MARINO ENGINEERING ASSOCIATES, INC.

Re: Review of Brook Mine Application – Rounds 8 to 12

As you have requested, we have reviewed the relevant sections of the mine application and related documents for the proposed Brook Mine as it relates to mine subsidence potential and their effects and geotechnical reclamation issues. These materials include those prepared by Ramaco, WCC Engineering, Agapito Associates, Inc., Wyoming Department of Environmental Quality, and Engineering Analytics, Inc. A list of these documents reviewed for this report are provided in Attachment A.

FIGURE 2 NEW PROPOSED MINE PLAN OF THE BROOK MINE SHOWING THE ADJACENT OLD WORKS

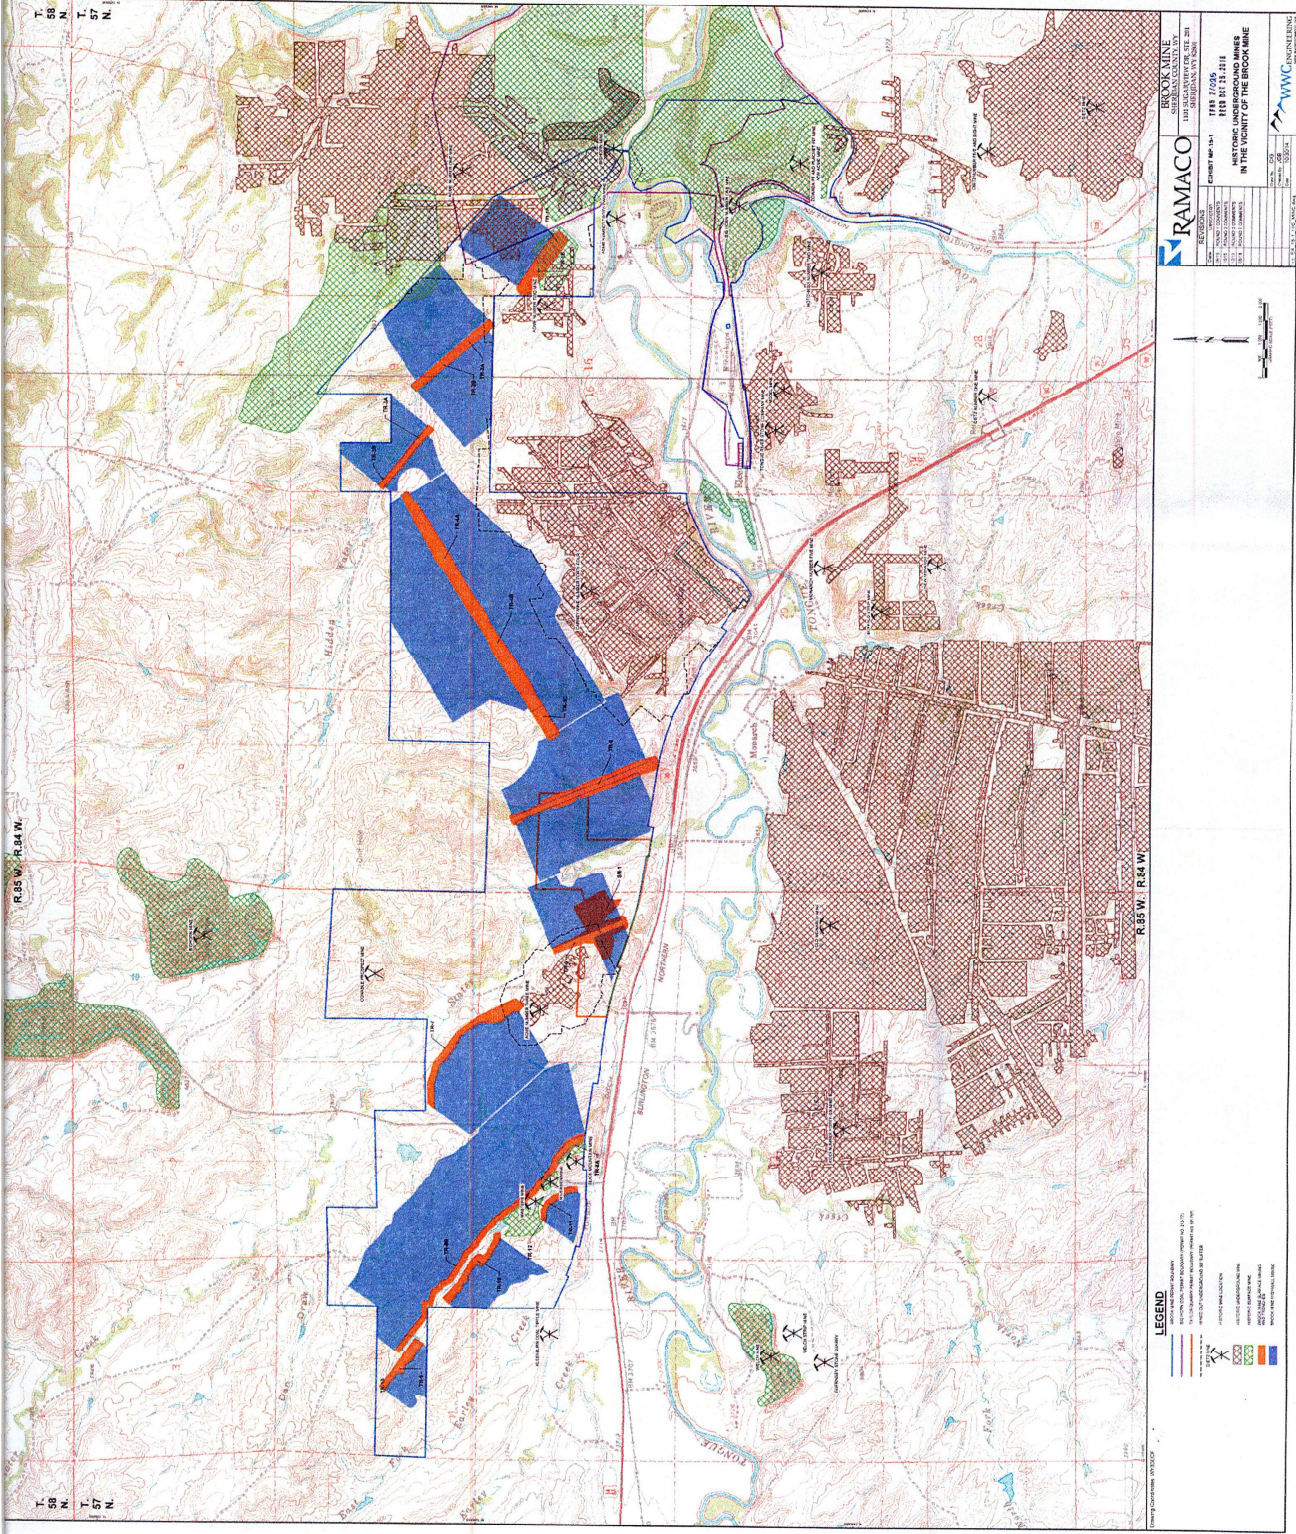
The new proposed HWM TR-1 area consists of only one block (in lieu Blocks 3 and 4 formerly TR-2, see MEA, 2017). The new mine plan is shown in Figure 2. Comparing Figure 4.3 (MEA, 2017) to Figure 2, it appears the changes in the mine plan only pertain to the old TR-1 and TR-2 areas. Consequently, the HWM areas which were Blocks 9 and 16 in Figure 4.3 still abut against old workings with minimum barrier coal of 0 to 70 ft. and consequently result in potentially flooding from the old workings to the south especially considering the likely inaccuracies of the mine map of the old works. Based on historical mapping, the floor depths in the minimum barrier areas are about 87 to 115 ft. in the new TR-4B, 5, and 7 areas. See Figure 2. Based on various empirical relationships on the minimum confirmed barrier thickness, this barrier should be at least about 55 to 110 ft. (Koehler and Tadolini, 1995), and therefore all areas (TR-4B, 5, and 7) would exceed the

FIGURE 3 SKETCHES OF THE THREE PRINCIPAL MODES OF FAILURE OF ROOM-AND-PILLAR MINE WORKINGS WHICH CAN RESULT IN SURFACE SUBSIDENCE

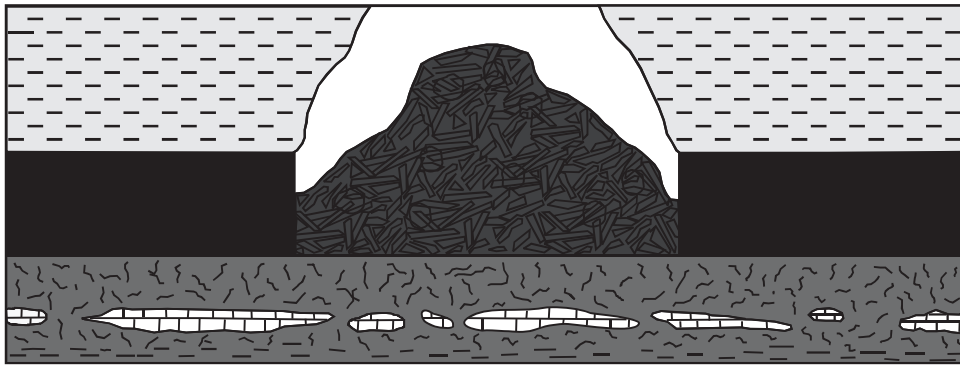
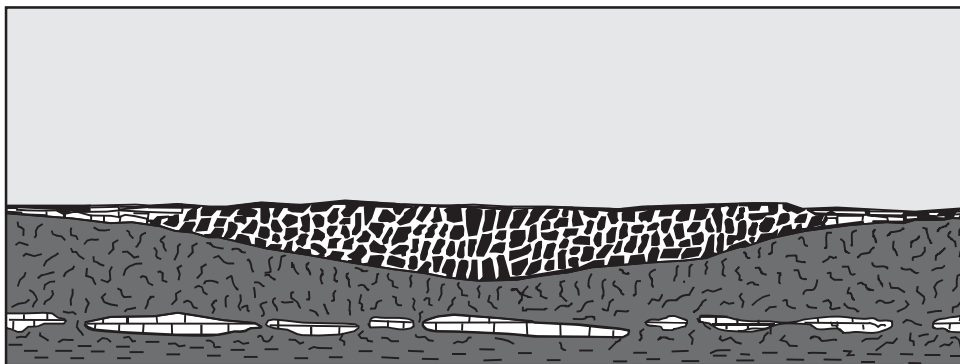
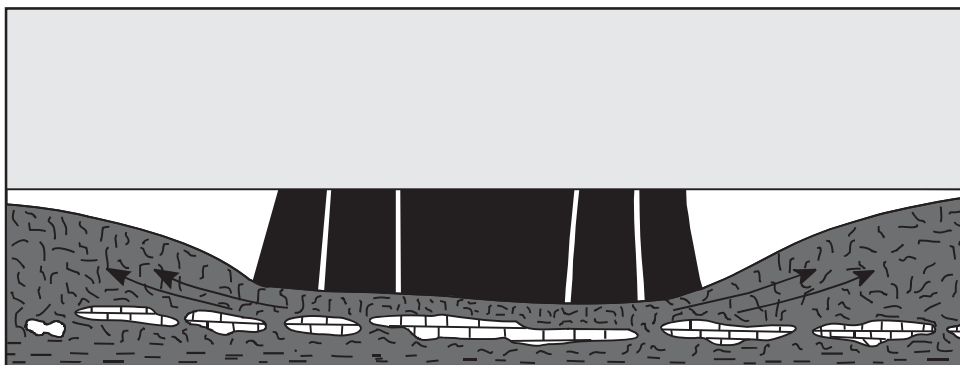
Below is the review of limited AAI mine design analyses against mine roof, pillar and floor failure based on the information available in the AAI report. See Figure 3.

Figure MP-6.2-4 Explanation of Variables in Equation MP-6.2-1 (Dyne, 1998)

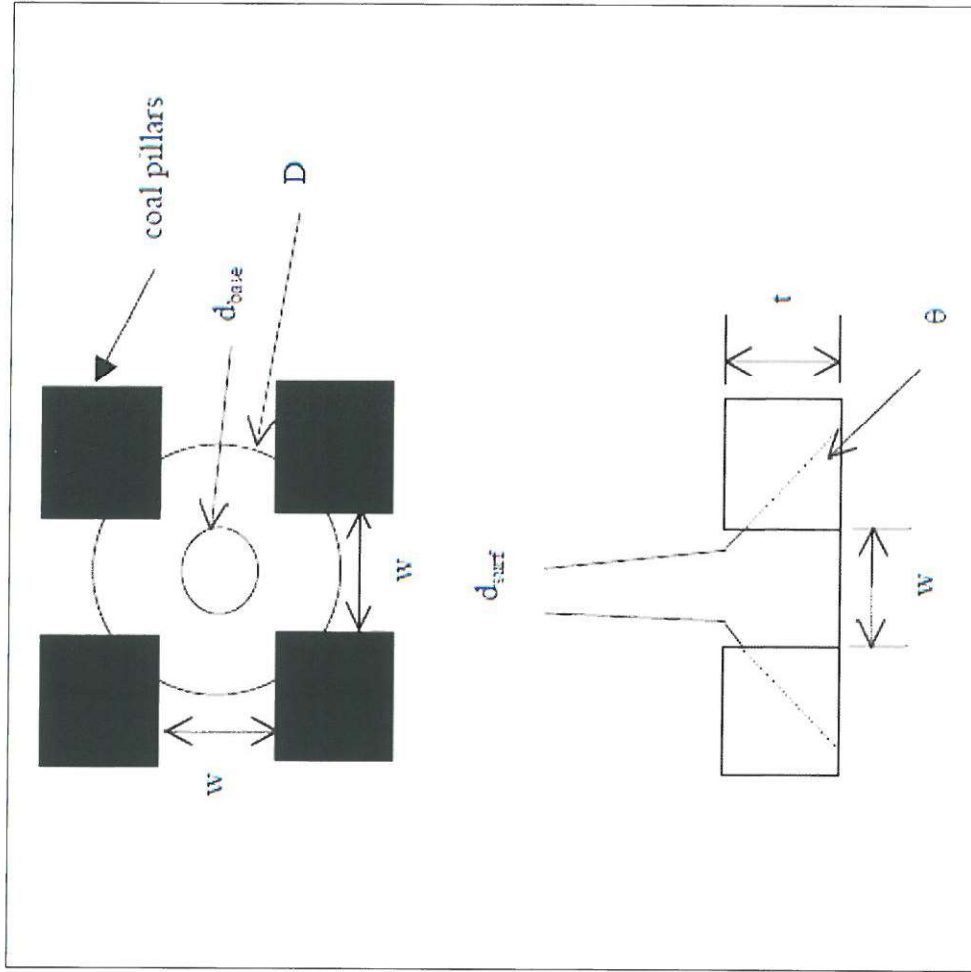
4. The method of “probability” used by AAI given above for sinkhole subsidence for HWM of the Carney seam in the TR-1 area is also in conflict with the methodology provided by Ramaco in the Subsidence Control Plan (SCP) for the overall application area. This methodology is discussed in detail in MEA, 2017. The methodology used by Ramaco recognizes the importance of other parameters in prediction of chimney subsidence which is ignored by the “probability” criteria used by AAI. Chimney prediction methodology (e.g., Piggott and Eynon, 1977, Garrad and Taylor, 1988, Whittaker and Reddish, 1989, and Dyne, 1998) typically considers at a minimum the bulking (volume expansion) from the caving of intact roof rock, the extraction height, width of intersecting mine openings and the repose angle or the spread of the caved material into mine openings. This was exemplified by Ramaco in Figure MP-6.2-4 (see Figure 4).
